NEW HAMPSHIRE
DEPARTMENT OF PUBLIC WORKS AND HIGHWAYS
AND
STATE OF MAINE - DEPARTMENT OF TRANSPORTATION
INTERSTATE 95 BRIDGE
OVER
PISCATAQUA RIVER
BETWEEN
PORTSMOUTH, NEW HAMPSHIRE AND KITTERY, MAINE

STATE OF MAINE
DEPARTMENT OF TRANSPORTATION
☐ Approved ☒ Returned for Corrections
APR 12 1977
☐ Approved as noted
☐ Approved as noted - Resubmit ☐ Rejected
L. L. Roberts
ASST. BRIDGE DESIGN ENGR.

DESCRIPTION DRAIN EXTENSION LAYOUT
PROJECT I-95 PISCATAQUA RIVER BRIDGE
LOCATION PORTSMOUTH, N.H. & KITTERY, ME.
ARCHITECT N.H.D. of P.W.&H. / S. of M.D.O.T. / HARDESTY & HANOVER
CONTRACTOR CHERNAK-BREDBENNER CONSTR. INC.
PAINT
HOLES
DRAWN BY MARCO KM
CHECKED BY MARCO
DATE 2-1-77
PROJ. NO. 77-262
DRWG. NO. E1

DESCRIPTION TRUSS ELEVATION - DRAIN EXTENSION
PROJECT I-95 PISCATAQUA RIVER BRIDGE
LOCATION PORTSMOUTH N.H. & KITTERY, ME.
ARCHITECT N.H.D. of P.W. & H. / S. of M. D.O.T. / HARDESTY & HANOVER
CONTRACTOR CHERNAK-BREDBENNER CONSTR. CO.

SECTION E-E

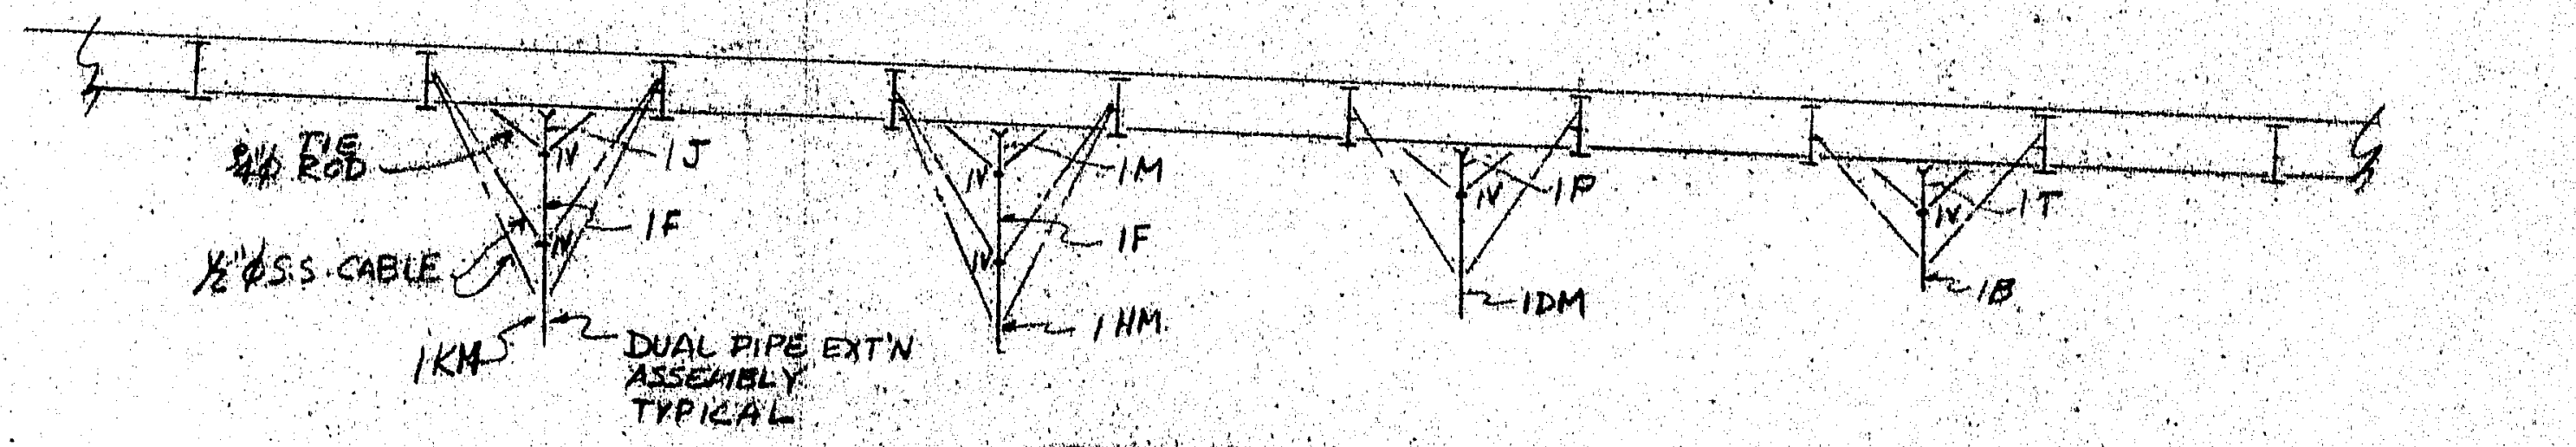
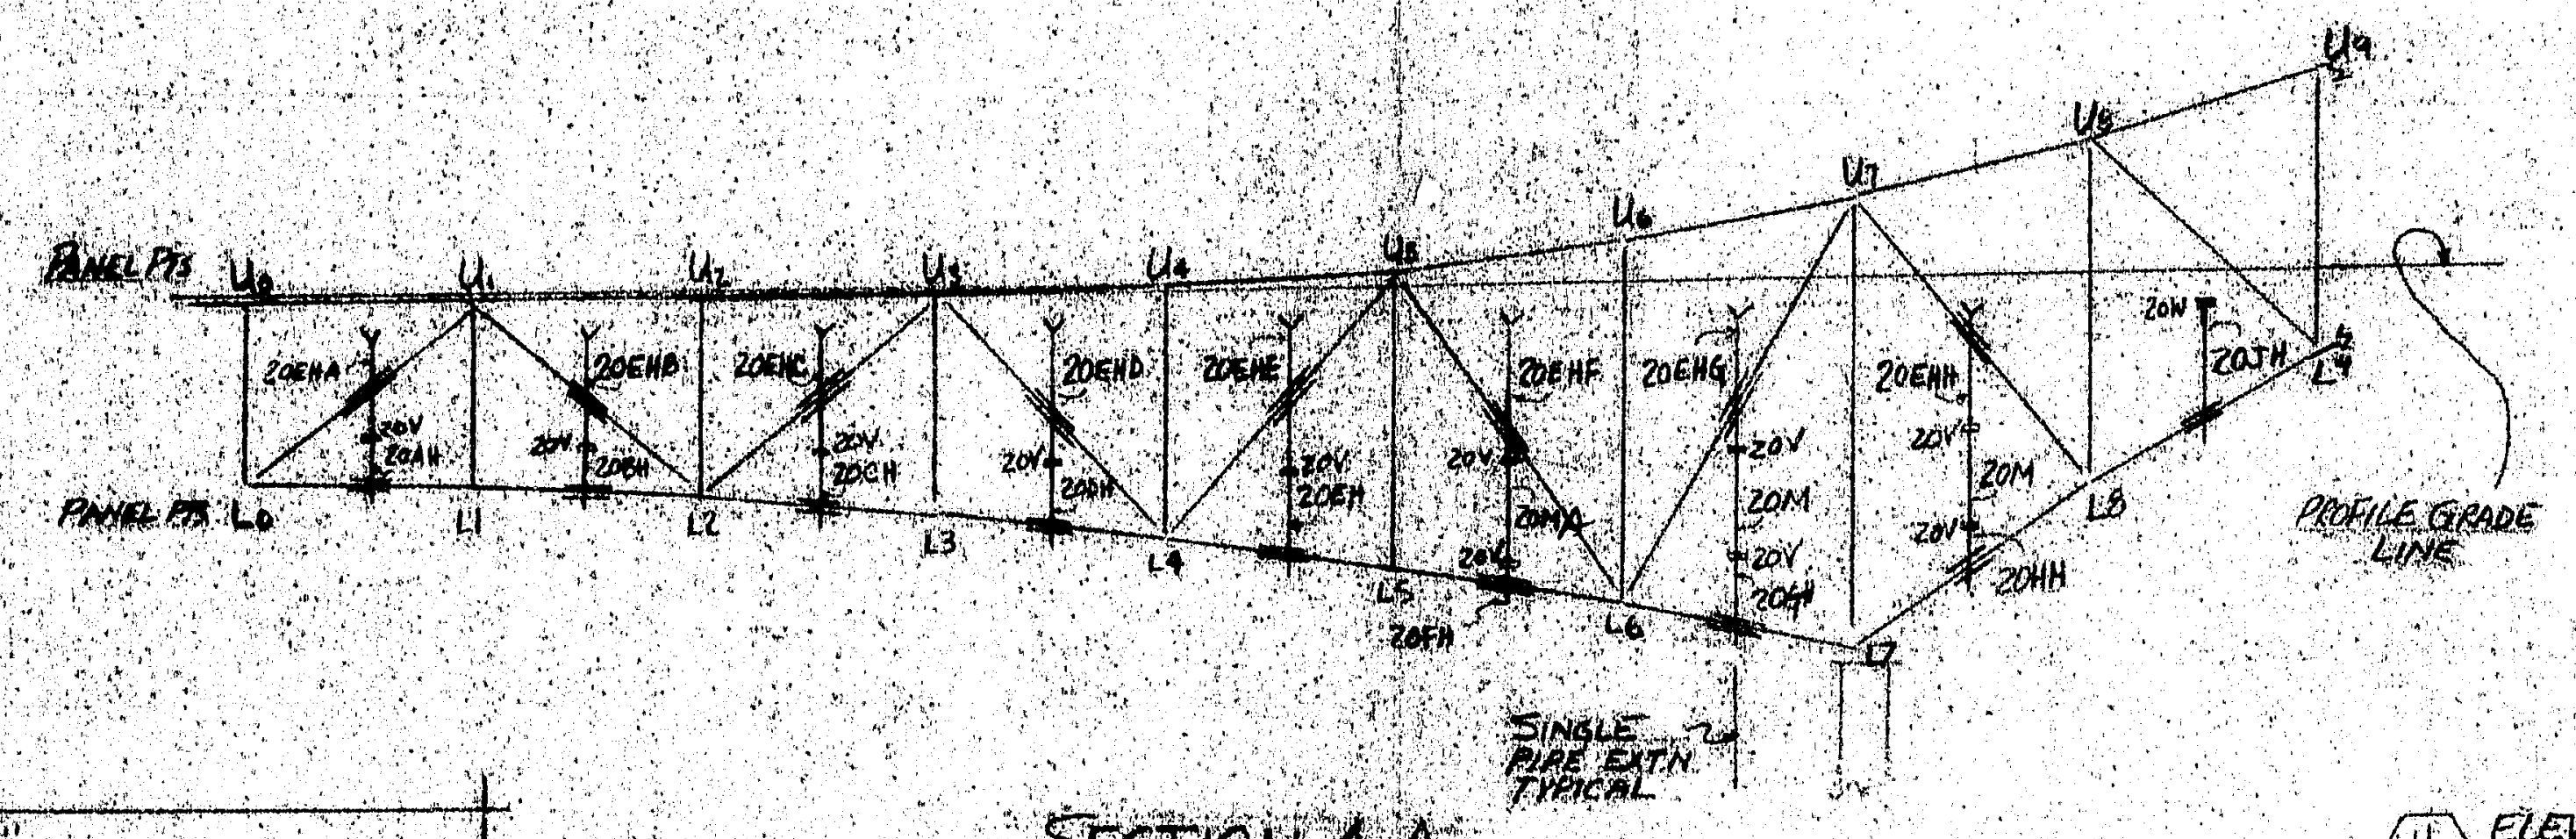
FIELD NOTE:
ALL DOWN SPOUTS TO BE HUNG PLUMB.

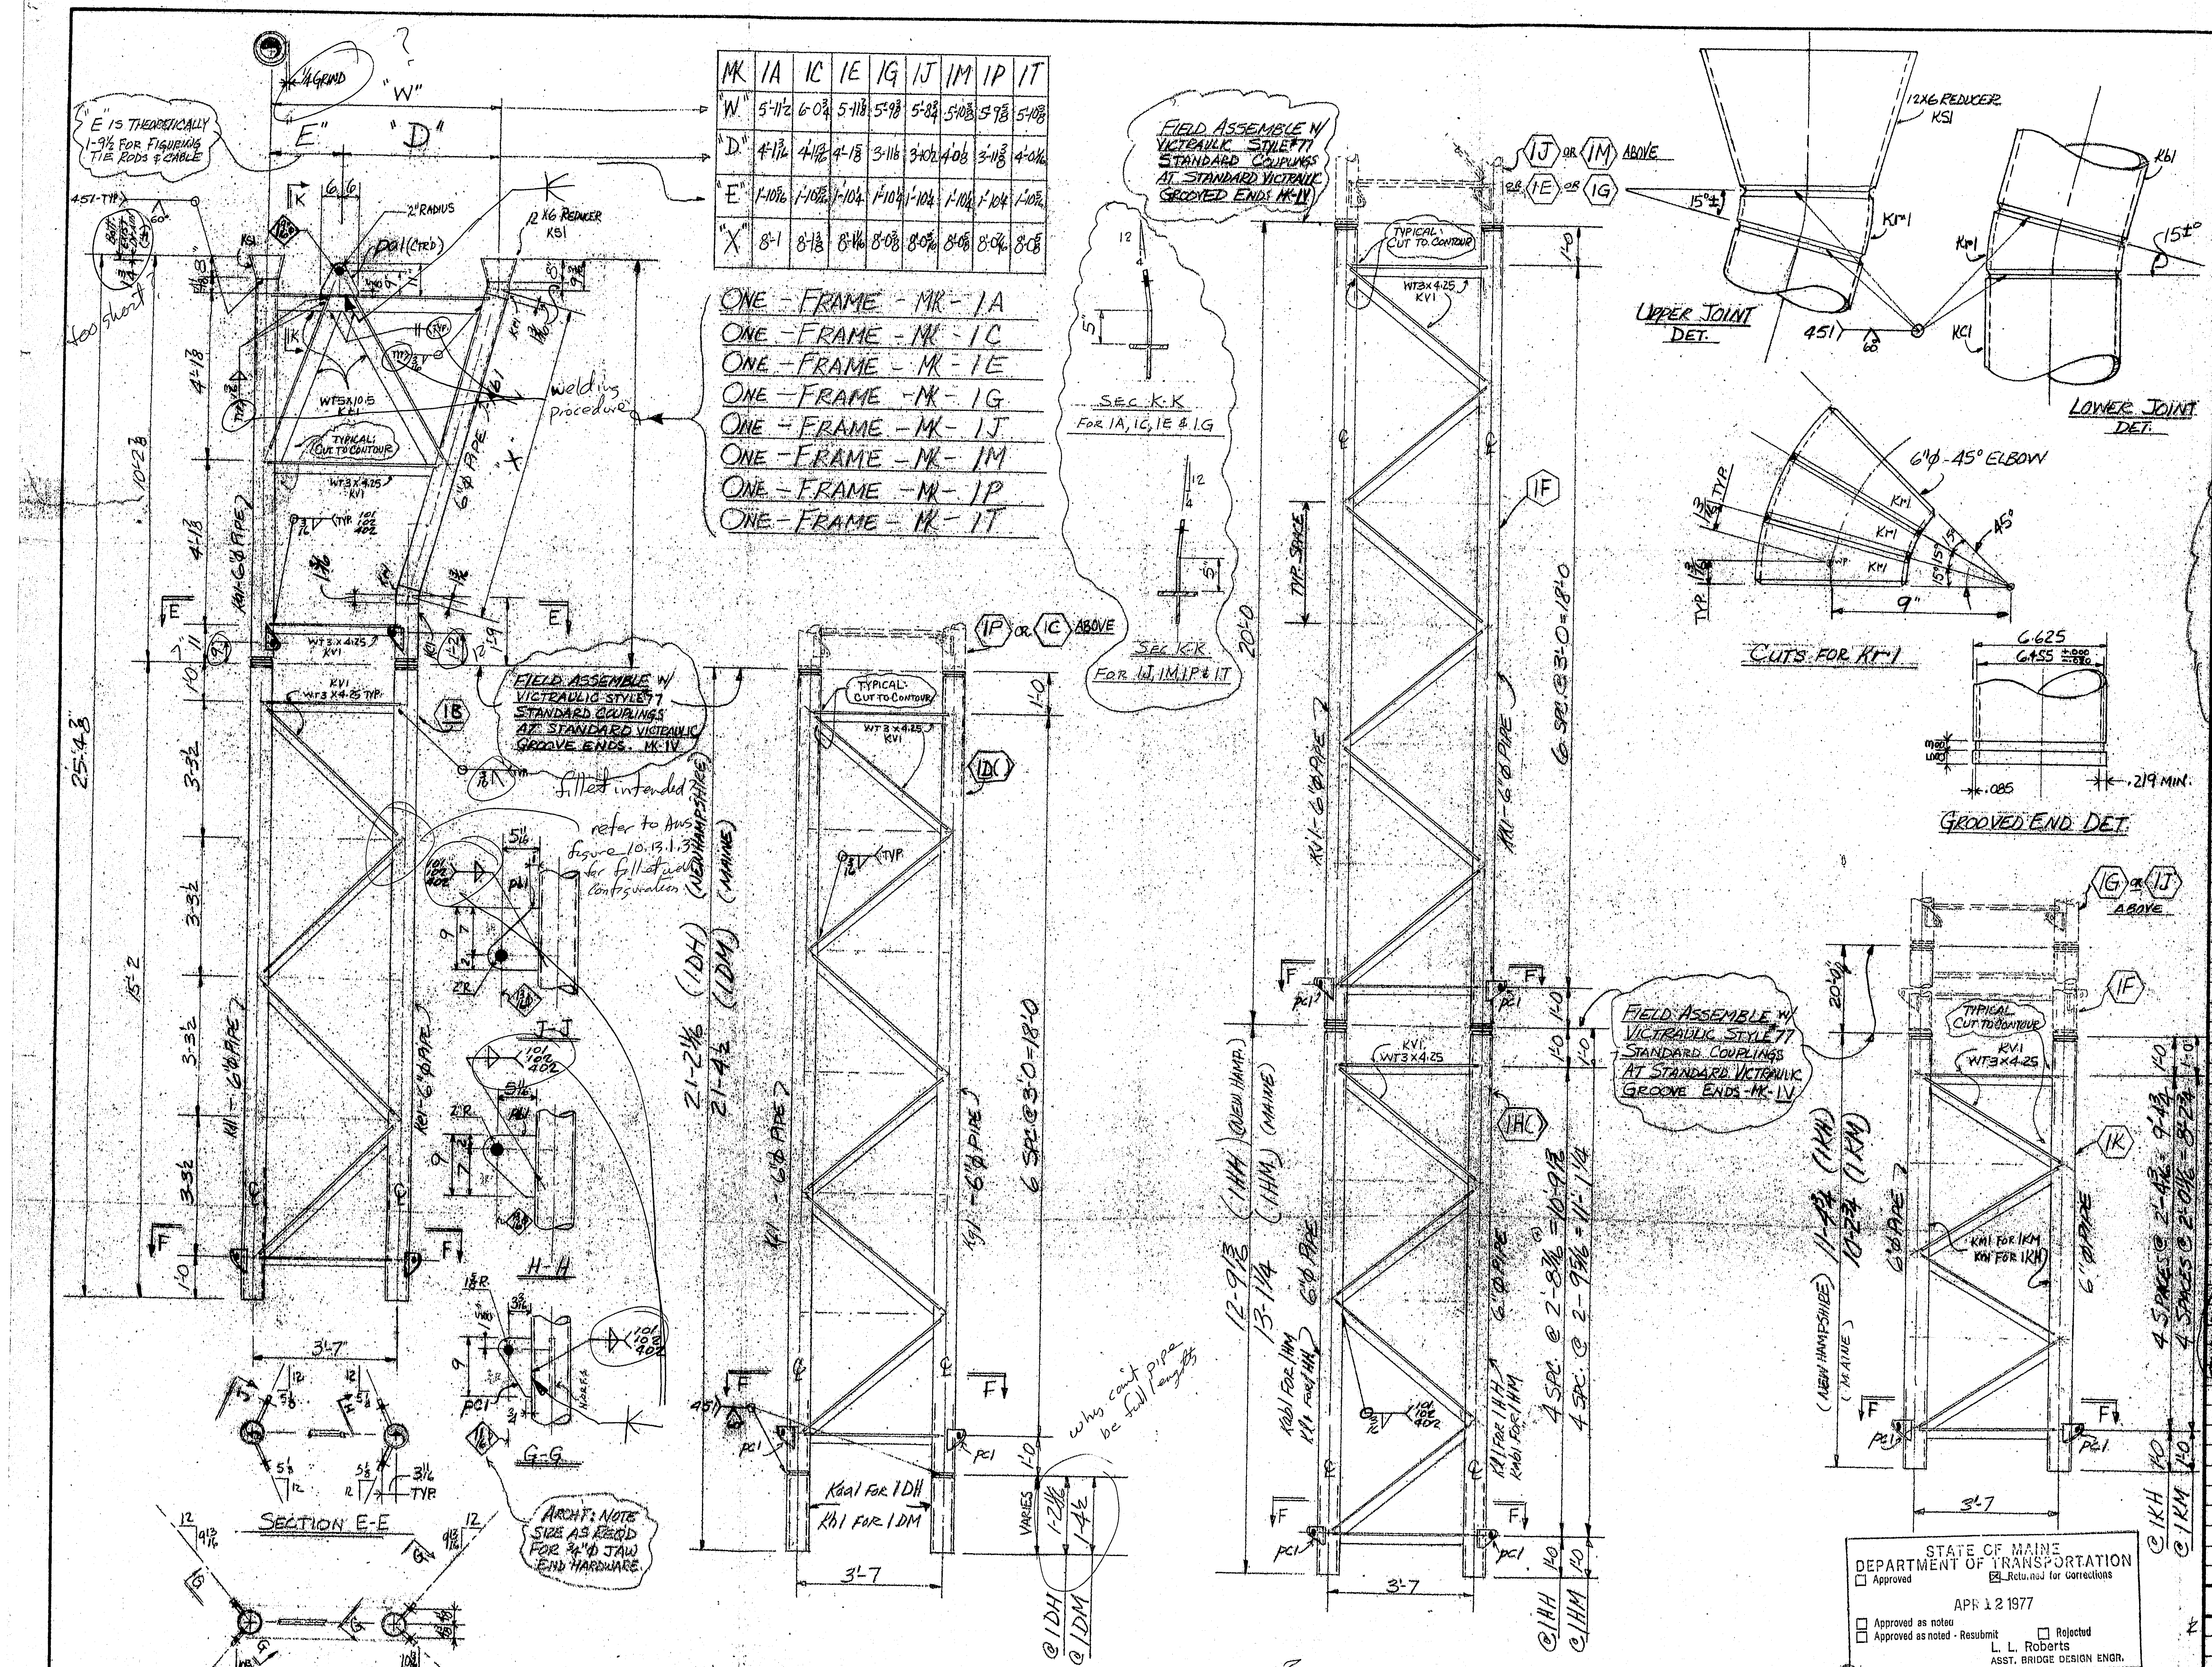
doesn't agree with 8' dim given in Elev.

GROOVES SHALL BE CUT BEFORE GALVANIZING

All galvanizing shall be in accordance with ASTM A153 & A123

All galvanized material shall be coated with Color Galv. paint

Define 1E & F1E

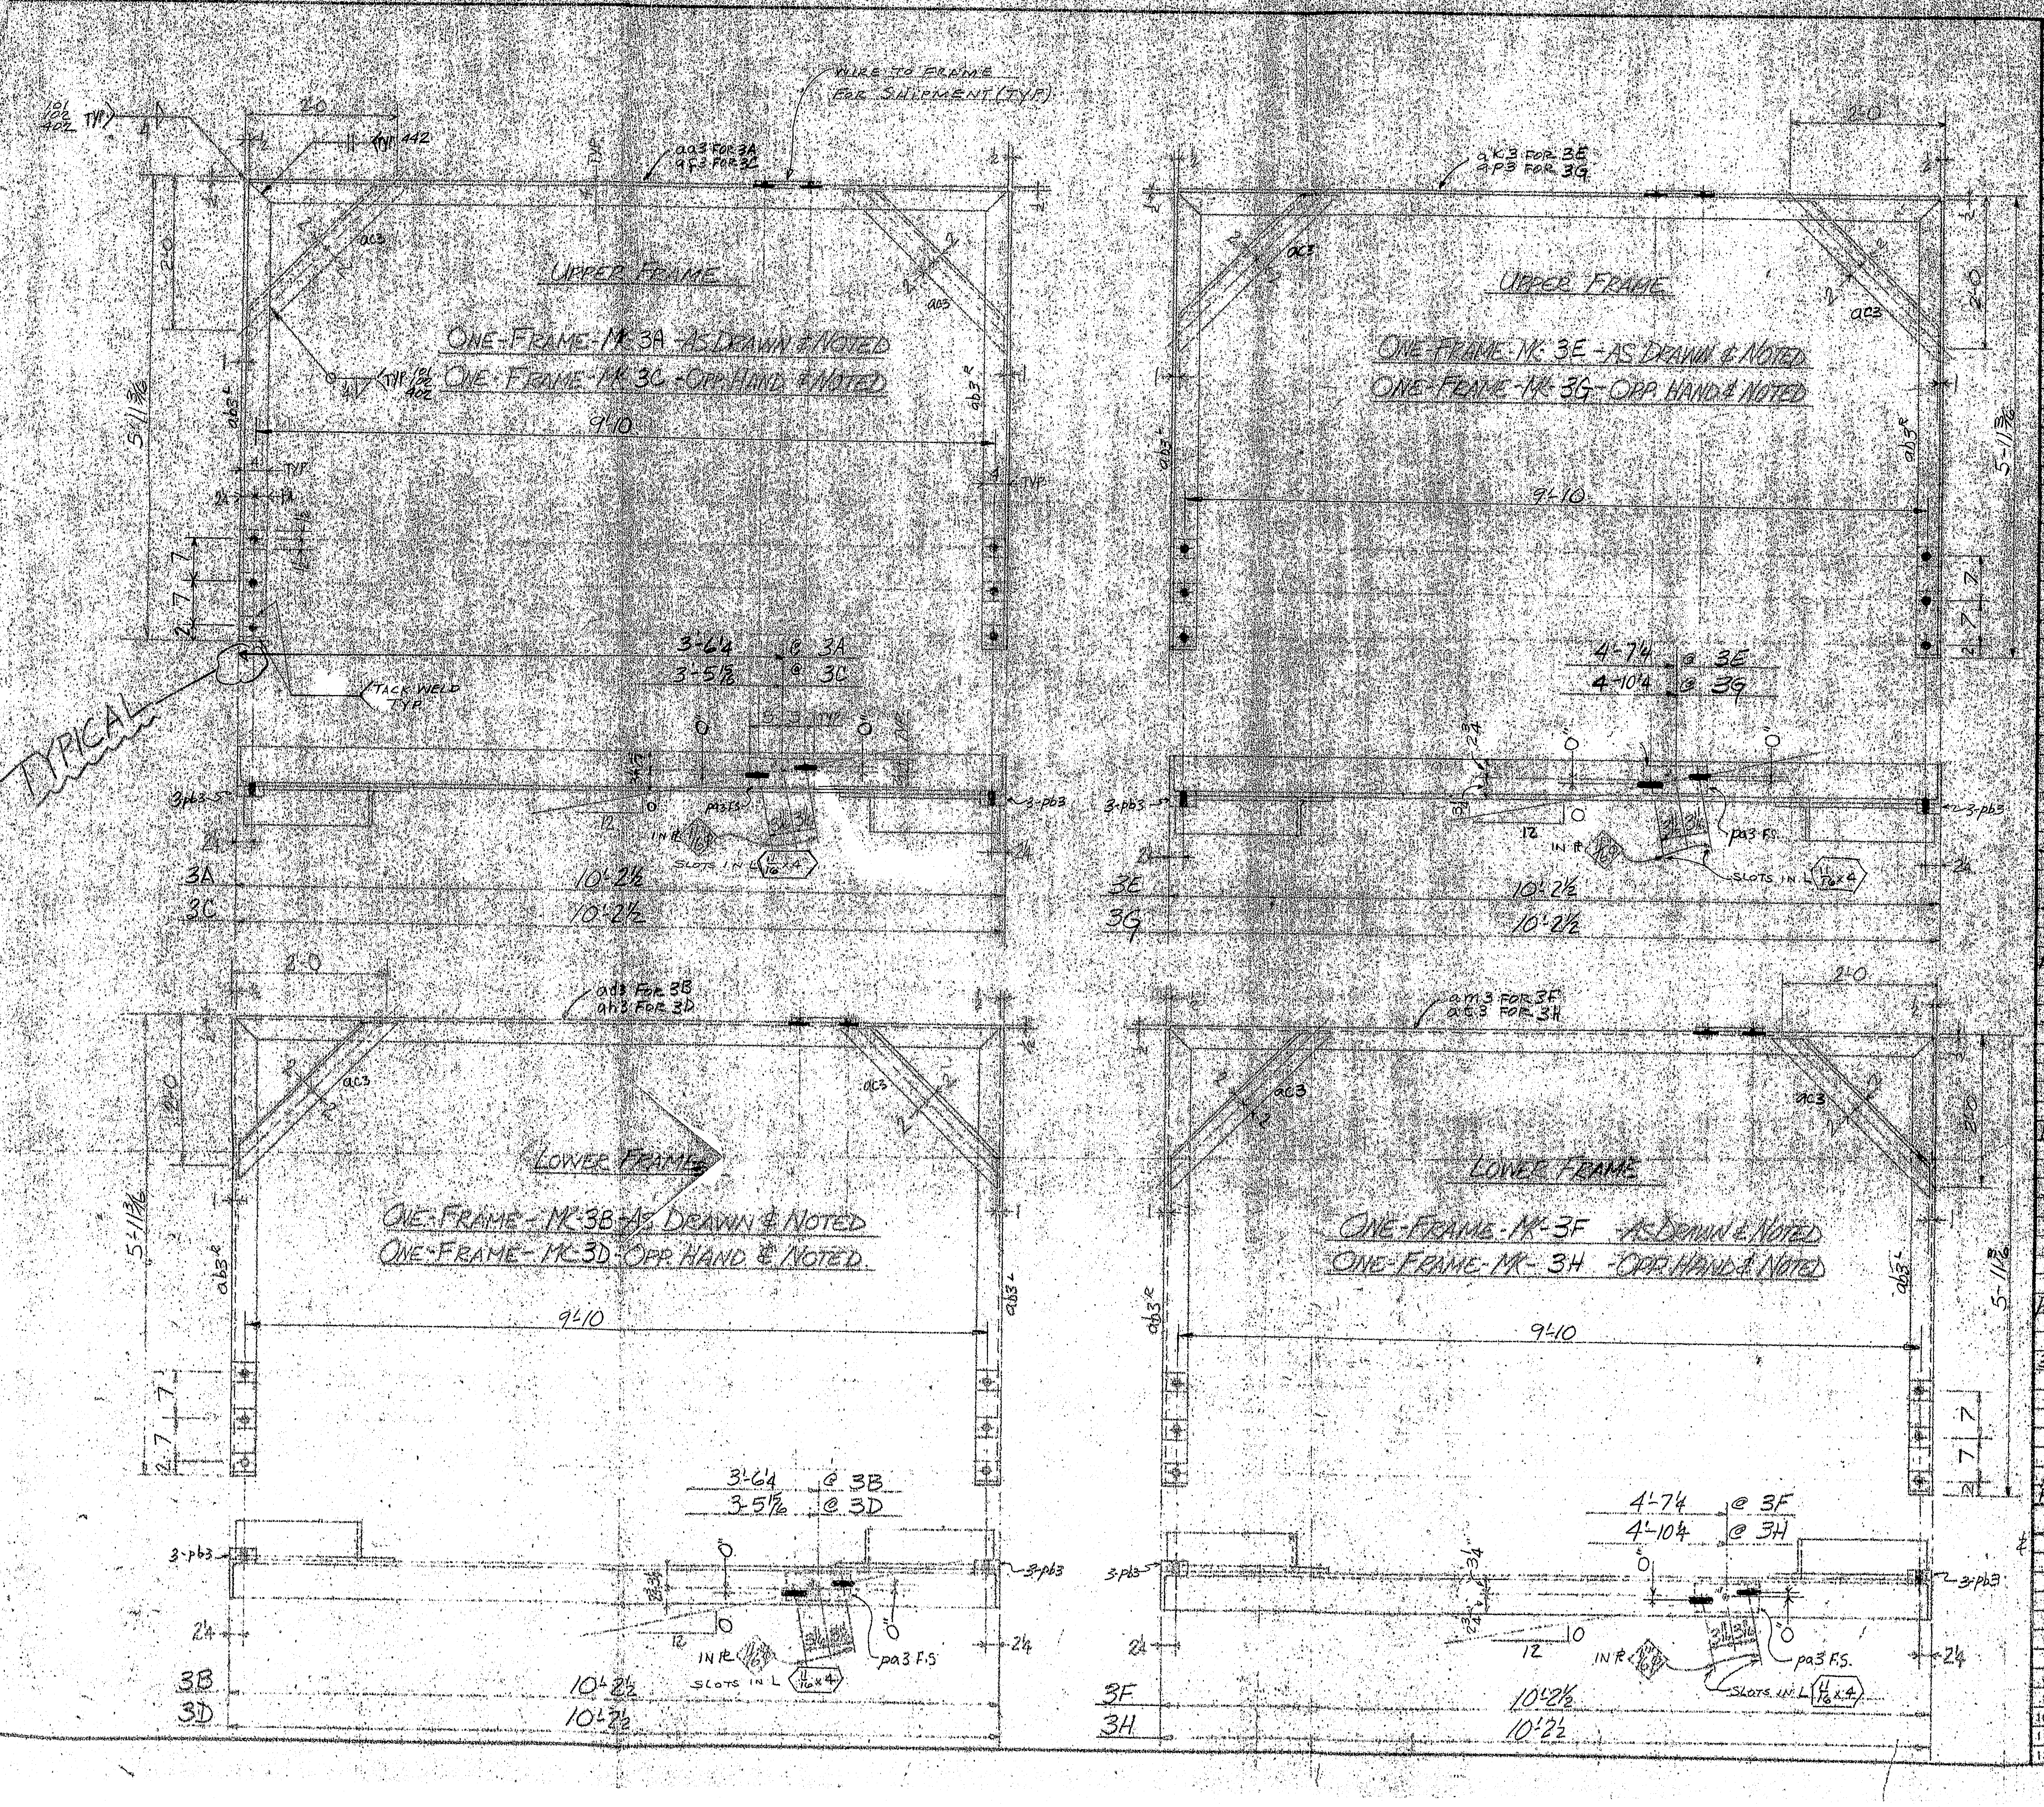
Supply material details and strength data

note areas which are not to be painted

galv. in accordance with ASTM A153

Same marks
